**WOKINGHAM
BOROUGH COUNCIL**

SUBMISSION OF DETAILS TO COMPLY WITH CONDITIONS

PLANNING PERMISSION 192928 (CONSTRUCTION OF THE SOUTH WOKINGHAM DISTRIBUTOR ROAD (SWDR) BETWEEN FINCHAMPSTEAD ROAD AND WATERLOO ROAD, INCLUDING A LINK TO HEATHLANDS ROAD, TOGETHER WITH ASSOCIATED WORKS)

CONDITIONS REFERENCES: 213417, 213430, 213441, 213554 & 213995

Condition 5 levels (213441)

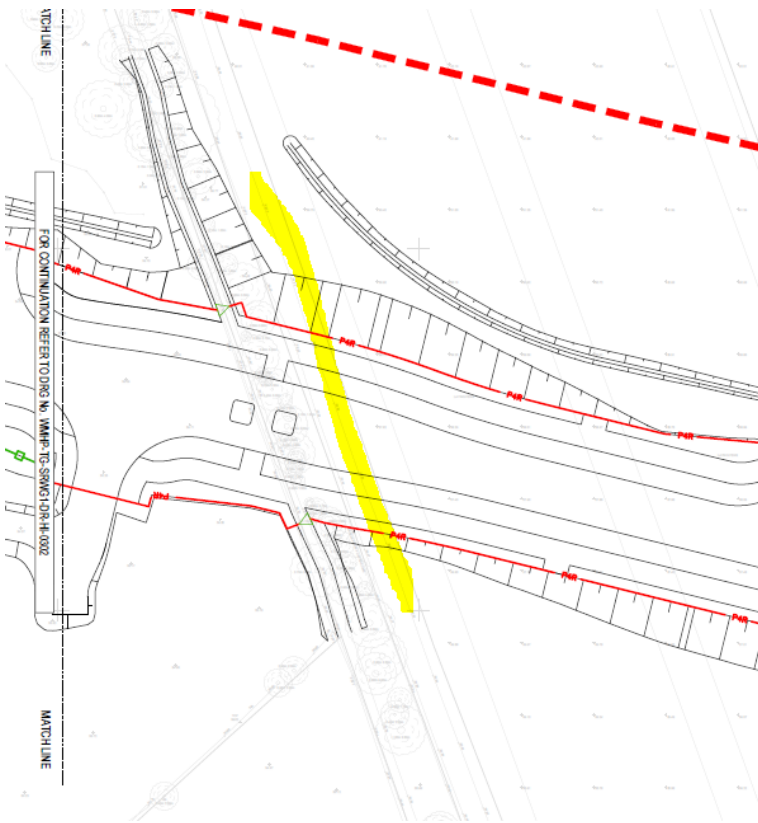
Please provide chainage drawings and longitudinal sections, as provided at the original application stage, showing existing, approved and proposed levels to allow comparison. I am aware that the consortium have raised concerns about the level of the road being increased and need to understand the scope of the issue.

and on WMHP-TG-SRWG1-DR-HI-301:

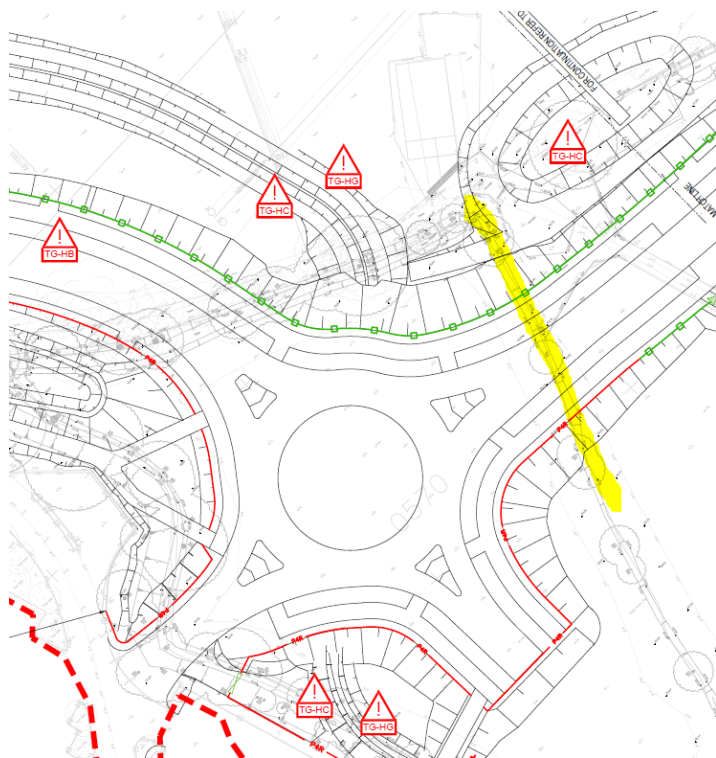
Additional mammal tunnels are required in these two locations, with reference to the fencing plans, on WMHP-TG-SRWG1-DR-HI-0303 (highlighted yellow):

Condition 11 AMS (213554)

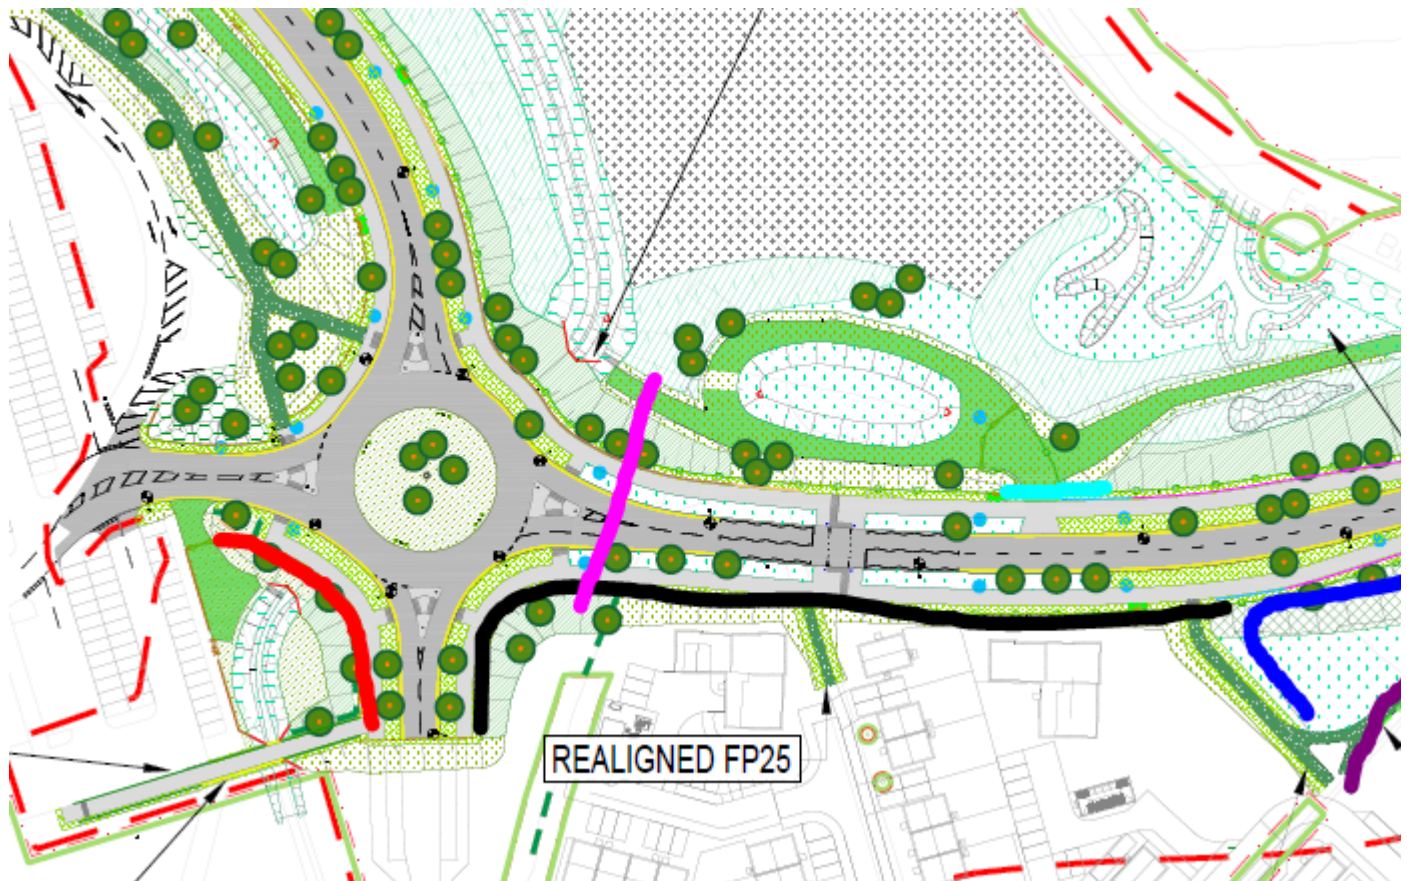
A revised AIA has been submitted but not an AMS which will need to be submitted to comply with this condition.

With reference to the WMHP-TG-SRWG1-DR-LS plans:

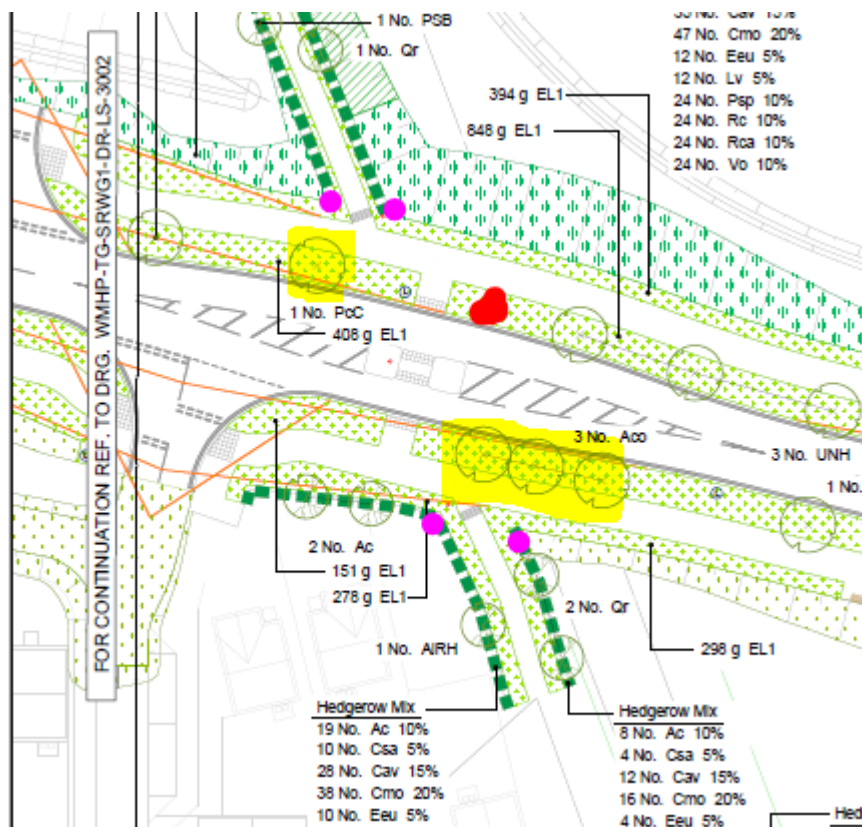
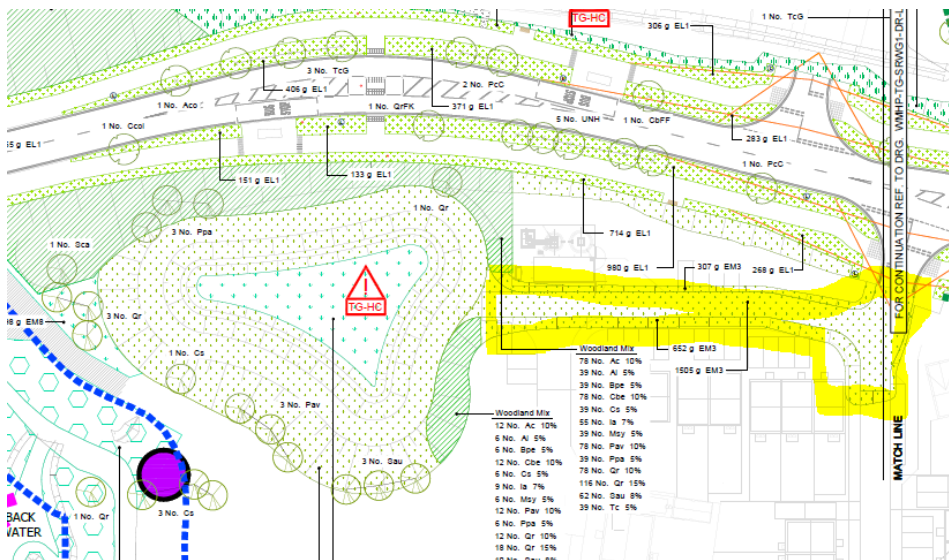
3002 P04 – The access path to the attenuation basin south of the SWDR is shown as being wildflower mix, which will not be the case in the long-term. The treatment of this area should be revised to reflect Persimmon's proposals and avoid the need for the wildflower grassland habitat to be considered in their baseline BNG assessment.
